## Rev B and D limitations and corrections

This errata document covers the first group with rev B and rev D.

Figure 4. VDD steady, VDDQ falls below its LVD threshold

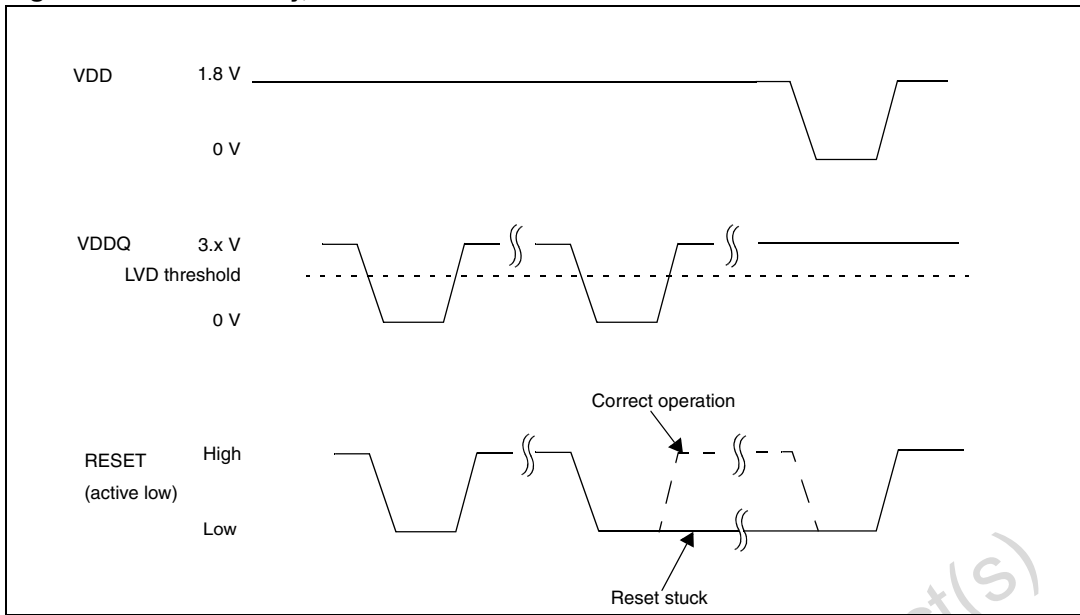
**Silicon Limitation:** The LVD logic is able to detect the first occurrence of VDD or VDDQ voltage drop that goes below the threshold voltage and it correctly generates an internal reset signal to the CPU and system. However, for subsequent drops of VDD or VDDQ voltage below threshold, the LVD logic generates an active internal reset signal, but the signal remains active (is stuck) even after VDD or VDDQ rises above the threshold again. The CPU is hung in a state of reset. A power cycle is needed on VDD to clear the stuck reset and release the CPU.

*Figure 4* illustrates the first case, when VDD is steady, but VDDQ falls below its LVD threshold. You'll see that the generated reset signal during the first drop of VDDQ is correct, and the reset is correctly deactivated when VDDQ returns to normal voltage. However, the second, and subsequent drops, of VDDQ will cause an active reset which remains active even after VDDQ returns to normal level. Only after VDD voltage goes through a power cycle will the reset signal deactivate.

An external reset supervisor device can be used to drive the RESET\_INn input pin on the STR9. The LVD must be switched off in this case. This limitation will be fixed in the STR91xFA series.

Figure 5. VDDQ steady, VDD falls below its LVD threshold, but not below 1.2 V

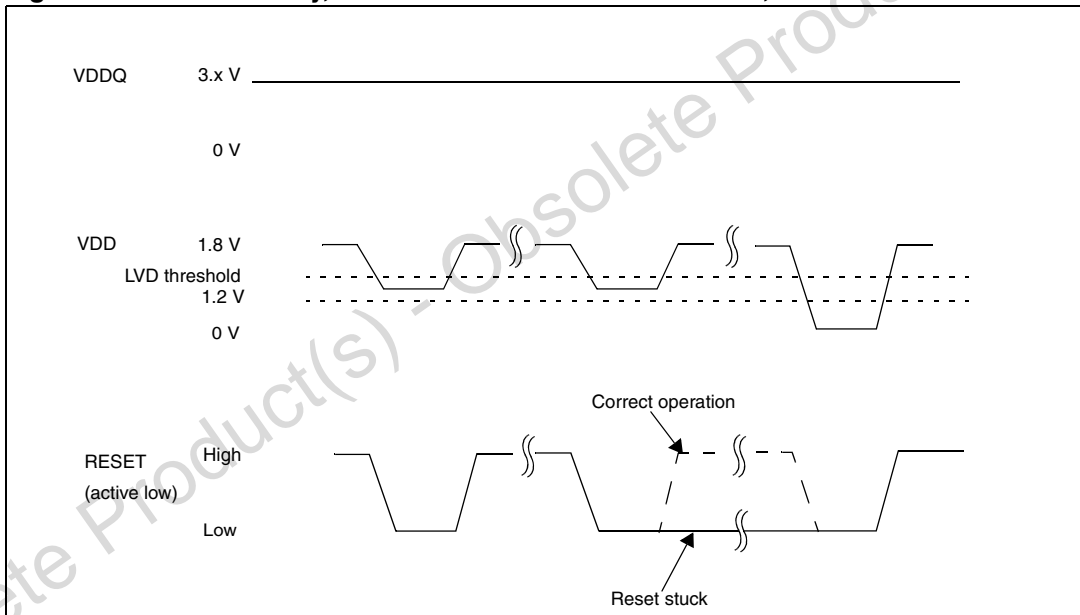
*Figure 5* illustrates the second case, when VDDQ is steady, but VDD falls below its LVD level, but not below 1.2 V (power-on-reset level). You'll see that the generated reset signal during the first drop of VDD is correct, but the second and subsequent drops of VDD will cause an active reset which remains active even after VDD returns to normal level. Only after VDD voltage goes through a power cycle (drops below 1.2 V) will the reset signal deactivate.

**Figure 6. VDDQ steady, VDD falls below its LVD threshold, and below 1.2 V (no problems)**

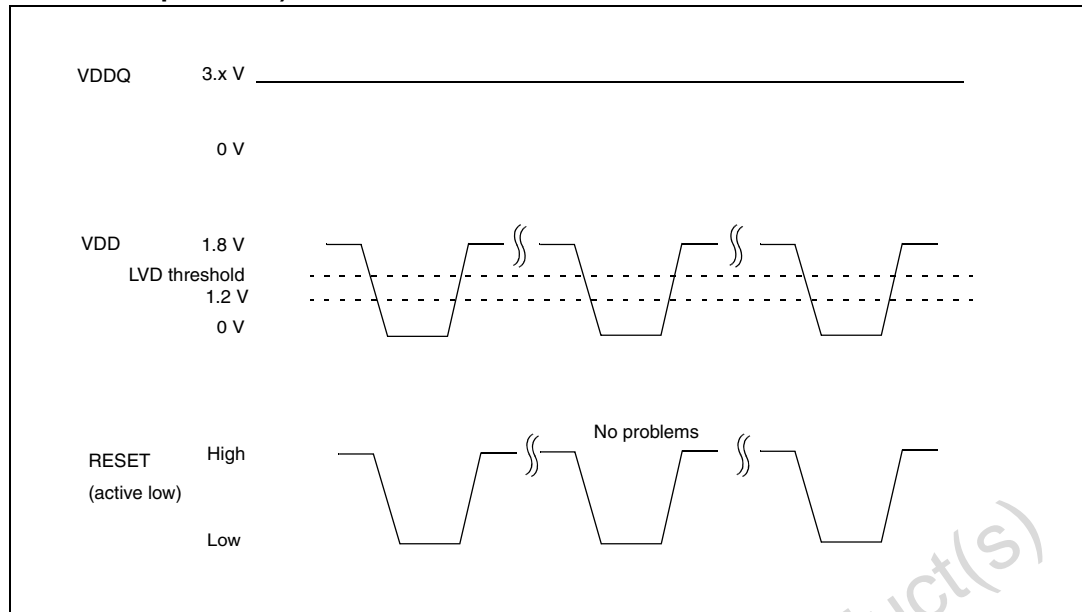
*Figure 6* illustrates the third case, when VDDQ is steady, but VDD falls below its LVD level, and falls below 1.2 V. In this case, there is no problem, the generated reset signal will activate and deactivate appropriately (will not get stuck).
